Water Resources Department

FINAL ORDER

Special Standards Request Form

REQUEST FOR WRITTEN APPROVAL TO USE CONSTRUCTION METHODS NOT INCLUDED IN OREGON ADMINISTRATIVE RULES 690-200 THROUGH 690-240

- (7) Diagram showing the pertinent features of the proposed well design and construction: (attach additional pages if needed)

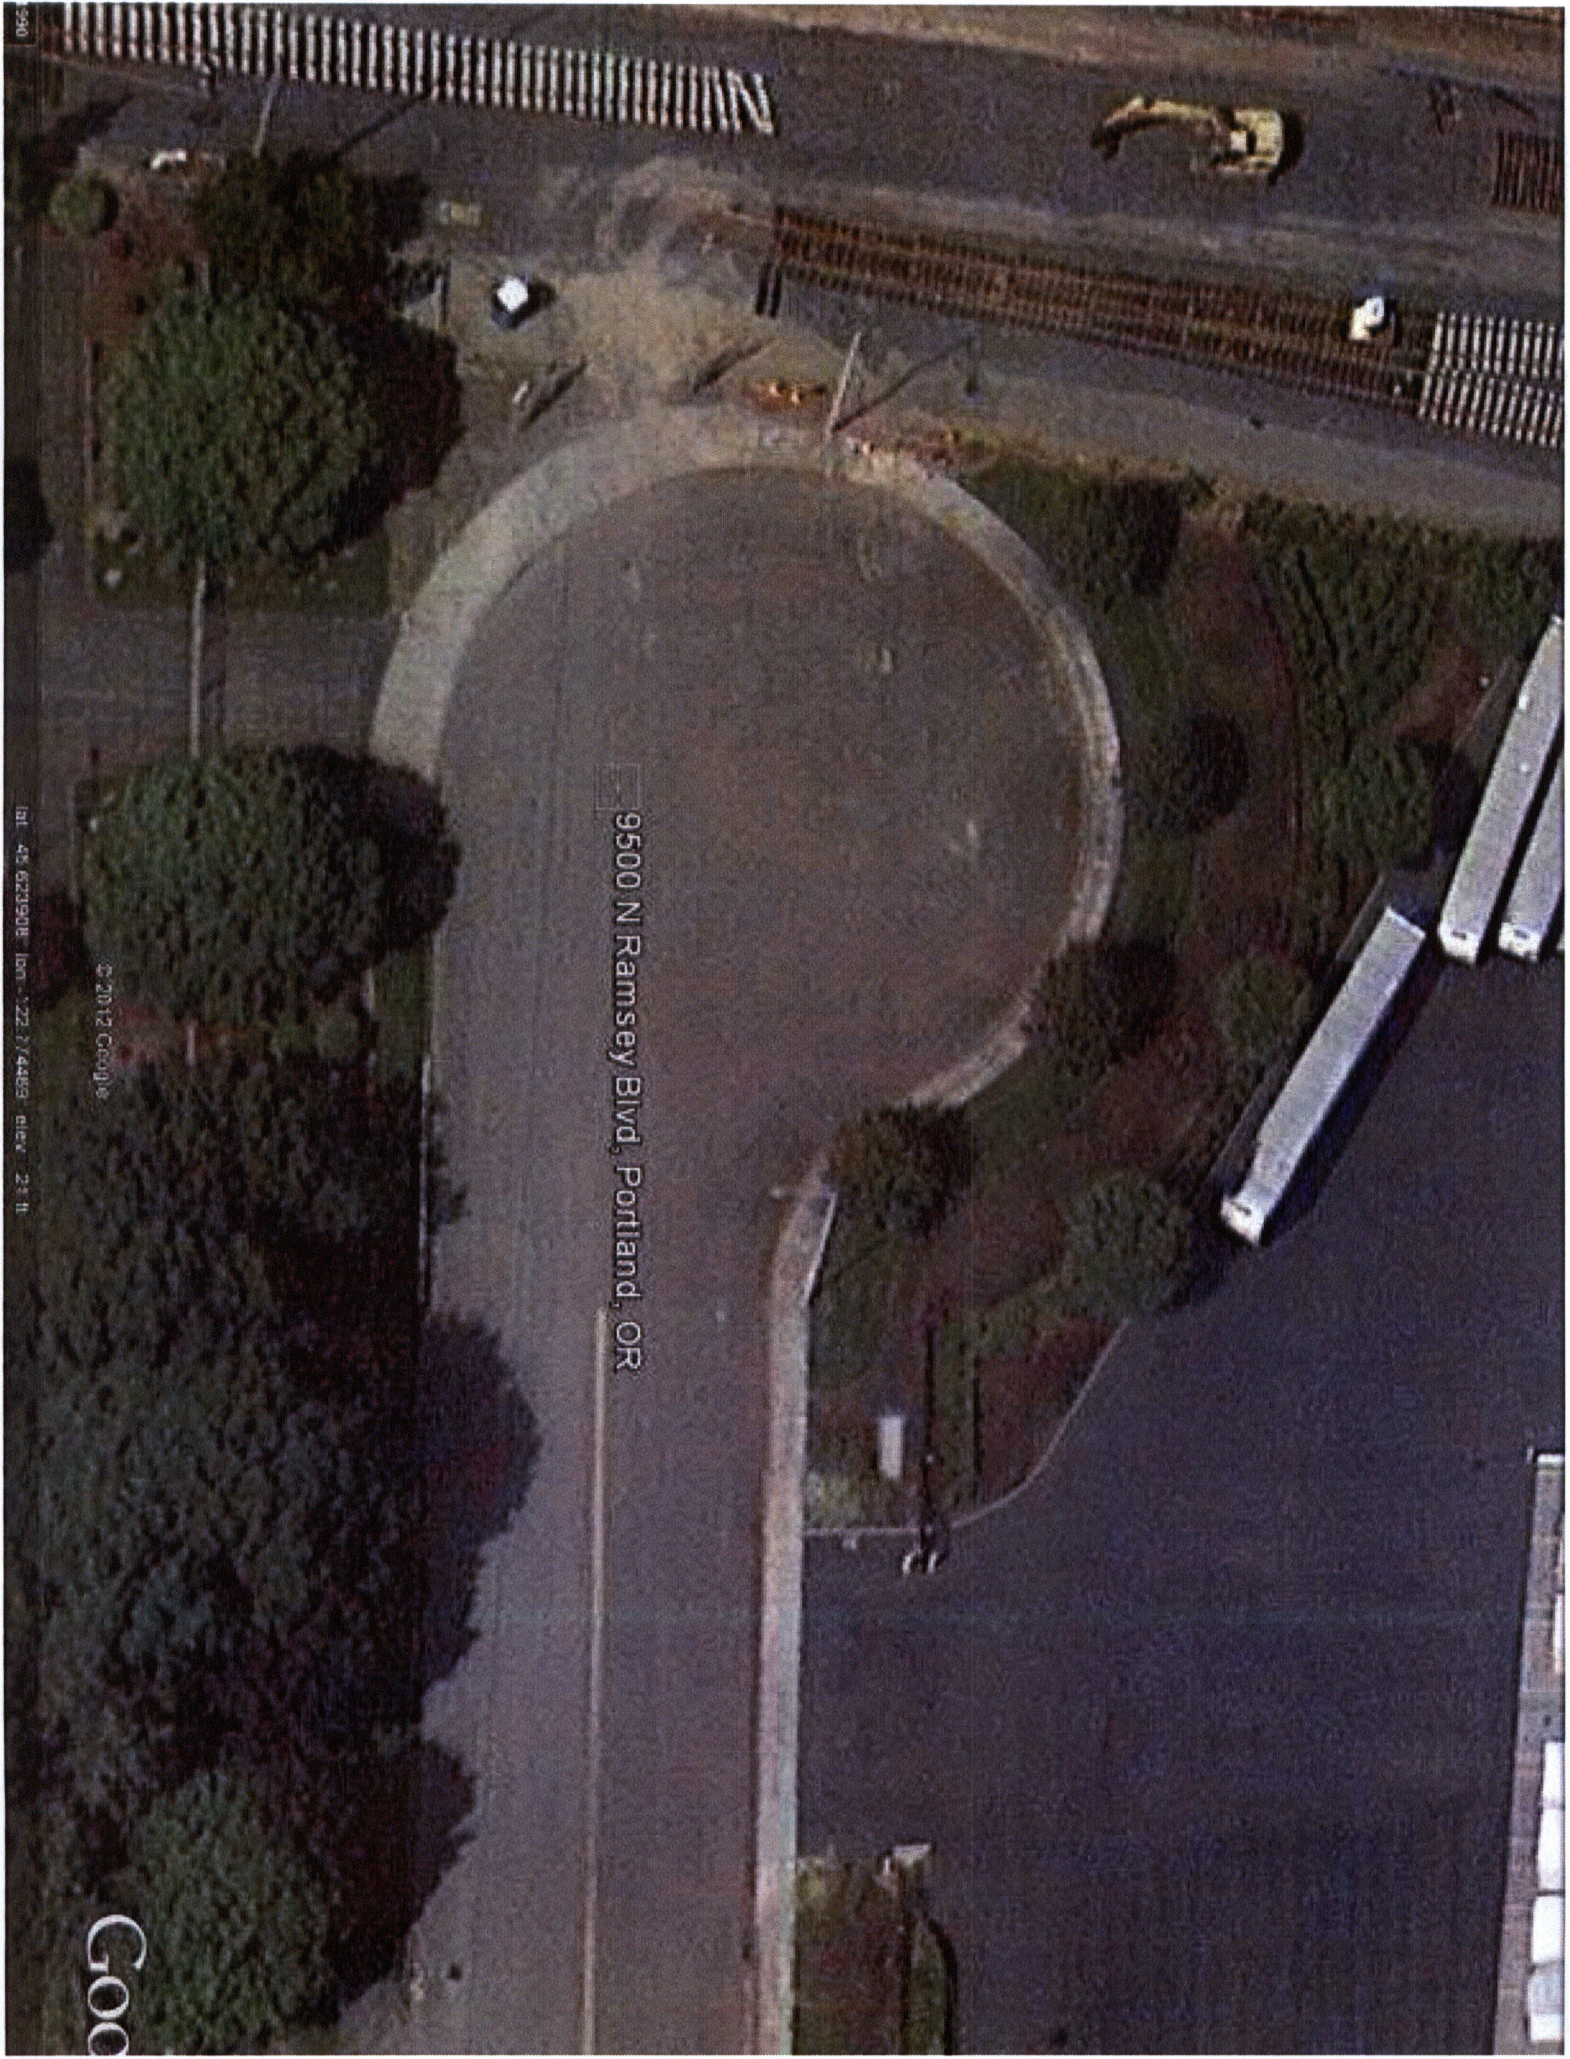
(5) The unusual site conditions which necessitate this request: Not practical to flush finish,
or to place bollards around each temporary dewatering well point in single pumping system. Location is
fenced in construction area in middle of street.

(6) The proposed construction methods that the bonded well constructor believes will be adequate for this well: (attach additional pages if needed)
1. Temporary well points will be abandoned within 60 days.
2. Well points are located within a 6 feet high fenced construction site.
3. Intend to finish each well point connected to a single system pump.

The Special Standards Request Form you submitted for owner: City of Portland, Start Card number 1016396, is hereby approved for the following: You may construct this collector dewatering well system with three foot bentonite seals and no well monuments. The collector well points may only be connected to a single header and they may only be constructed into the uppermost aquifer. The wells may not commingle aquifers when completed. As a reminder, a well I.D. label is required to be attached to the dewatering system. *A stipulation of this special standard is that these wells must be permanently abandoned within 60 days from the date of this final order.* Your Special Standards Request Form is enclosed. All other standards must be adhered to.
